R48 – 2018

**Certificates of Appropriateness for work in the Historic Districts:
620 Park Street, 946 North Street**

**CITY OF ALLENTOWN
HISTORIC ARCHITECTURAL REVIEW BOARD
FINAL REVIEW SHEET
March 5, 2018**

Case # HDC-2018-00011 – Proposal to continue the installation of ceramic tile over wood porch boards.

Property located at: 620 Park St.

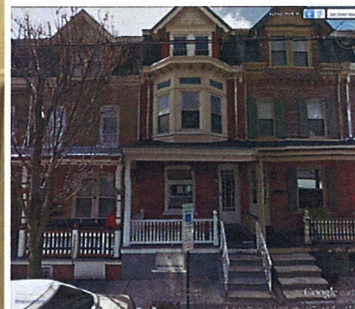
Evaluation, effect on historic district, recommendations: The current work in progress is not historically appropriate and does not follow guidelines for appropriate material substitution or replacement. The original porch floor was wood and should have been repaired in-kind, or,

replaced with new tongue and groove wood flooring which is not expensive. Proper finishing, either stain or paint with sealant, and regular upkeep would allow a wood floor to last years since it is a covered porch. The existing tile should be removed and the wood porch decking be repaired or replaced to match the original.

Discussion: The HARB explained why adding tile to the historic wood porch decking was not historically or functionally appropriate. Mr. Brobst told the applicant that the mortar joints were not water tight and water infiltration would rot the porch floor quickly. The applicant asked how long they had to remove the tile from the porch and how to fix the wood deck. It was explained that the existing historic porch decking might be able to be repaired, but if not it would need to be replaced to match the old. It was concluded that Mr. Kimmerly should inspect the porch decking after the tile was removed to give the applicant direction or repair or replacement of the decking.

1. The proposal to continue the installation of ceramic tile over wood porch boards at 620 Park Street was presented by Claudia Fernandez.
2. The ceramic tiles installed on the porch must be removed.
3. The applicant has 4 months, until June 30, 2018, to complete the work.
4. After the tile is removed, the applicant must contact Mr. Kimmerly to determine the conditions and give direction on the repair or replacement of the wood porch floor decking.
